STANDARD CONCRETE PRODUCTS, INC.
SUBDIVISION, RESUBDIVISION OF LOTS 1 & 2

APPLICATION NUMBER 6 DATE November 17, 2022

APPLICANT Standard Concrete Products Inc Subdivision, Resubdivision of Lots 1 & 2

DETAIL SITE PLAN

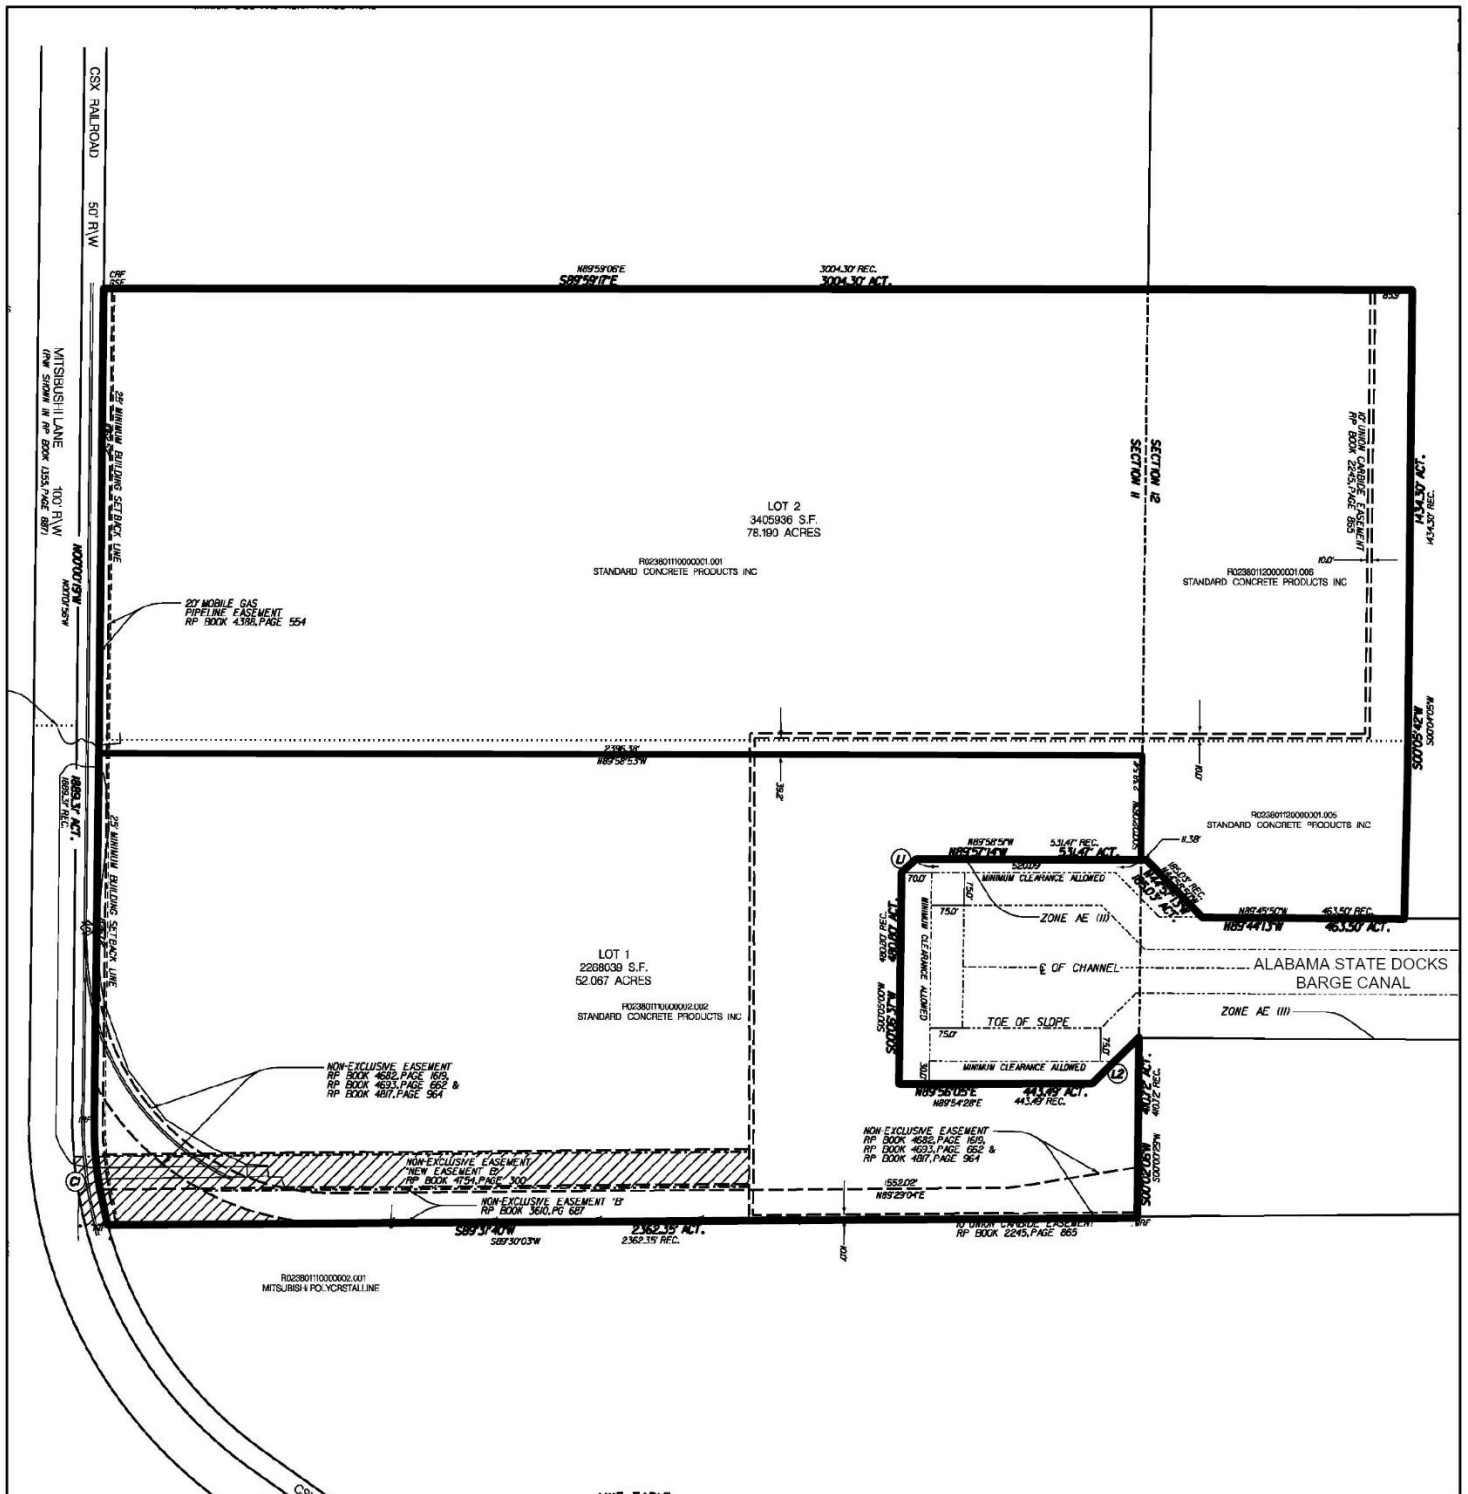
- A. Provide all of the required information on the SUBDIVISION PLAT (i.e. signature blocks, signatures, certification statements, written legal description, required notes, legend, scale, bearings and distances) that is required by the current Alabama State Board of Licensure for Professional Engineers and Land Surveyors.

- B. Provide and label the monument set or found at each subdivision corner.
- C. Show and label all flood zones. The AE and X(S) zones appear to cross onto the property (LOT 1 & LOT 2).

- D. Show and label the MFFE on each lot that contains an AE, V, or X (shaded) flood zone designation. BFE = 11'.
- E. Provide the Surveyor's, Owner's (notarized), Planning Commission, and Traffic Engineering signatures.

- F. Add a note to the SUBDIVISION PLAT stating that as shown on the 1984 aerial photo LOTS 1 and 2 will receive historical credit of existing (1984) impervious area towards stormwater detention requirement per Mobile City Code, Chapter 17, Storm Water Management and Flood Control) as follows: LOT 1 – NONE and LOT 2 –NONE.

The preliminary plat indicates numerous easements within the site for vehicular access, utilities, railroads and surrounding industries. Therefore, a note should be placed on the Final Plat stating that no structure is allowed in any easement without the approval of the easement holder.

- 1) retention of the lot size labels in both square feet and acres on the Final Plat, or the furnishing of a table on the Final Plat providing the same information;
- 2) retention of the easement information for Mitsubishi Lane on the Final Plat;

- 3) retention of the 25-foot minimum building setback line along Mitsubishi Lane on the Final Plat;
- 4) placement of a note on the Final Plat stating that no structure is allowed in any easement, without the approval of the easement holder;
